Service Bulletin

Title: Conversion of the Bell 429EC Air Conditioner Electrical Provisions to accommodate the Allied Blower Motors.

Applicability: Bell Helicopter Model 429 Helicopters equipped with the electrical provisions for the Fasco motors.

Figure 1: Wire Schematic Change for Section I

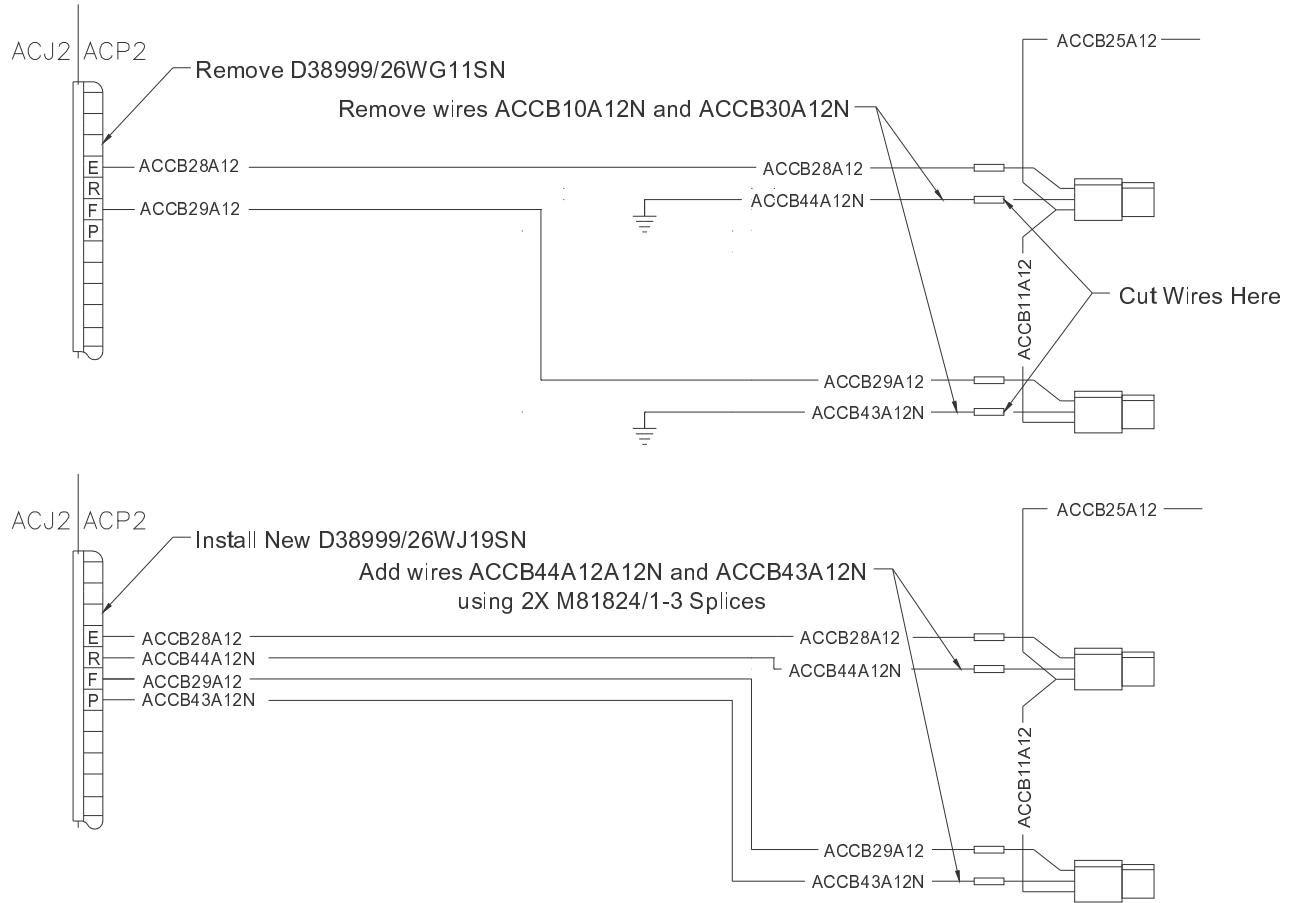
1. Remove left and right forward evaporator local ground leads ACCB10A12N and ACCB30A12N from GND 1. Find wires between M81824/1-3 Splices and Molex connectors. Cut wires close to the M81824/1-3 splices. See Figure 1.
2. Crimp pins on ACCB43A12N and ACCB44A12N then insert into ACP2 along with ACCB28A12N and ACCB29A12N per
3. Figure 1. Install wire per Figure 3,4,5.
4. De-pin ACP2 connector (D38999/26WG11SN) and replace with new D38999/26WJ19SN. Install new M85049/43-24W backshell on D38999/26WJ19SN connector. See Figure 1,4.
5. Remove relay panel stowage bracket 429EC-8430-1 and replace with new 429EC-8430-3 stowage bracket. Connect ACP2 plug to stowage bracket. See Figure 4.

Figure 3: Right Side of Fwd Cabin Harness Installation Details

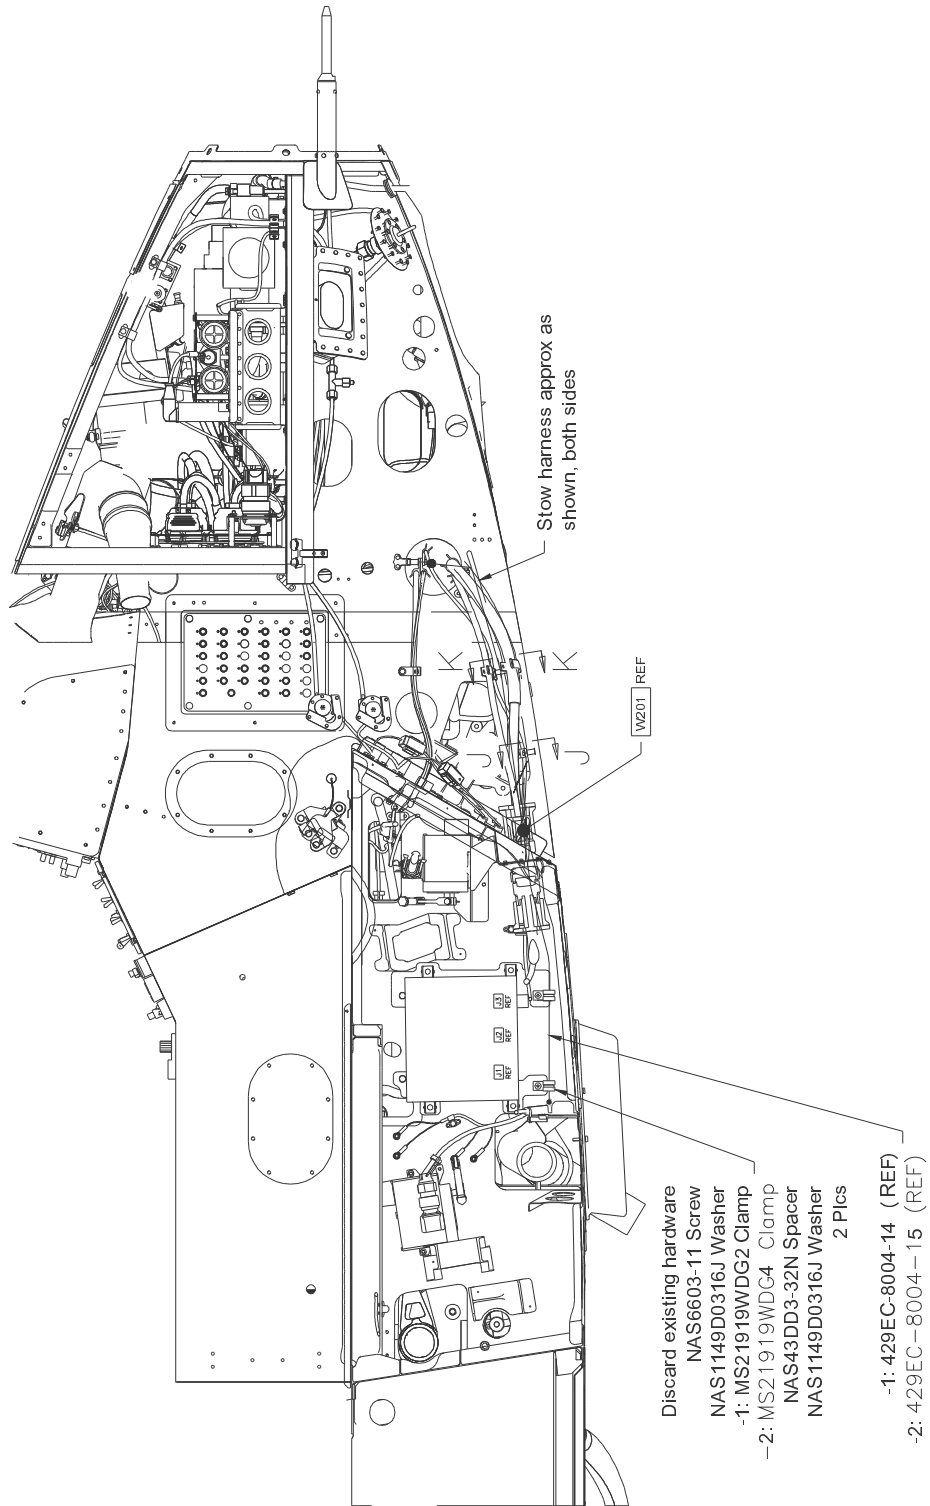
Revision	Issue Date	Inserted By	Description of Changes
N/C	14 Dec 2010	JB	Initial Release
A	27 Jan 2011	JB	Revised to match approved drawing revision: Page 2: "Parts to be installed" NAS6603-11 Bolt was Screw. Page 5: Fig. 3, NAS6603-11 Bolt was Screw. M22759/41-12-9 wire was 04041-12-9. Added missing parts to "Parts to be Installed". Added Fig 6 620HB047B25 Backshell was M85049/43-24W.

Figure 6: Wire Schematic Change Section II

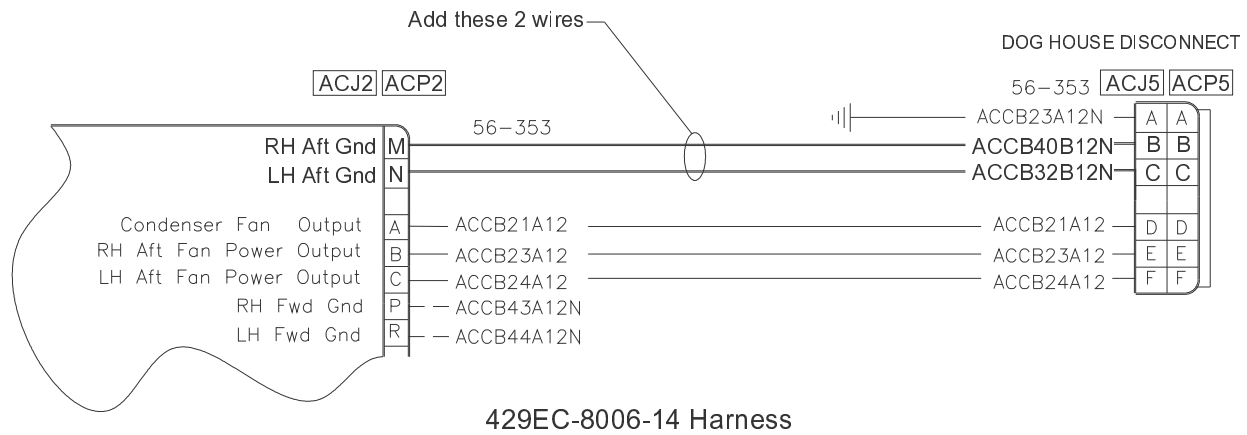
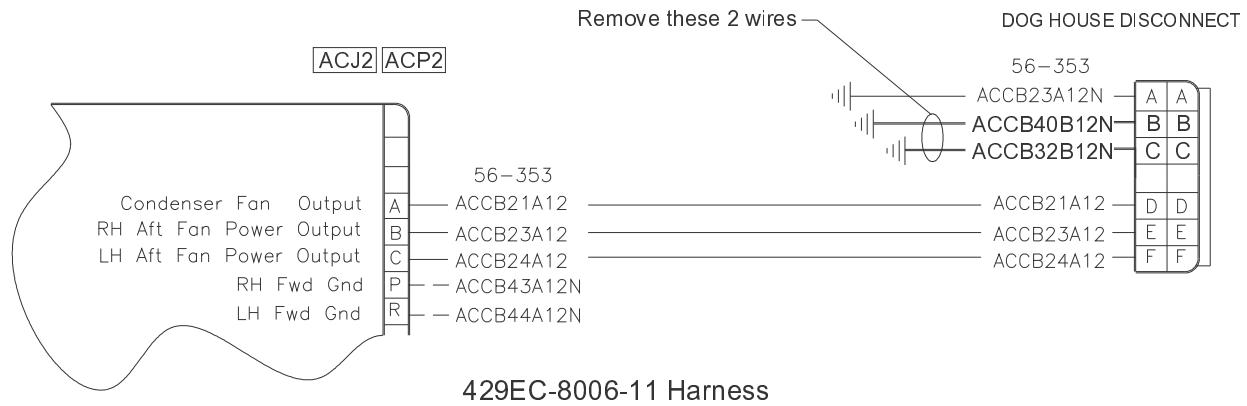
1. Remove left and right aft evaporator local ground leads ACCB40B12N and ACCB32B12N and discard. Install new left and right aft evaporator ground return leads ACCB32B12N and ACCB40B12N. Use 4x M39029/56-353 Pins at ACJ5 and ACP2 Cannon Plug. See Figure 6.
2. Crimp M39029/56-353 contacts on wire ACCB32B12N and ACCB40B12N. Insert wires into ACP2 connector. See Figure 6.
